# PRODUCT BULLETIN

Original Equipment Industries

**PRODUCT LINE:** Breathe JR Arm Pad Screw

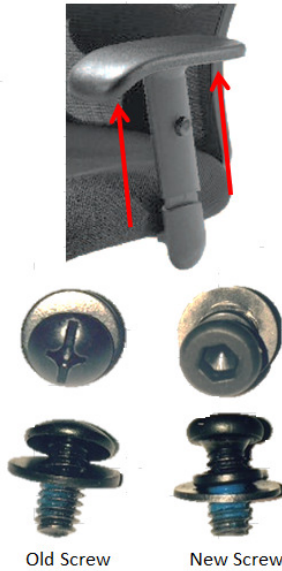
**DESCRIPTION:** Arm pad screw is changing from Phillips head screw/loc-tite patch/flat washer to (New) **Allen head screw/loc-tite patch/lock washer/flat washer.**

**REASON:** Allen head screw provides a more secure fit on bit to screw, easier assembly and allen head bit allows screw to reach proper tightness/torque. Lock washer in addition to loc-tite patch is to assure long term tightness of screw into pad.
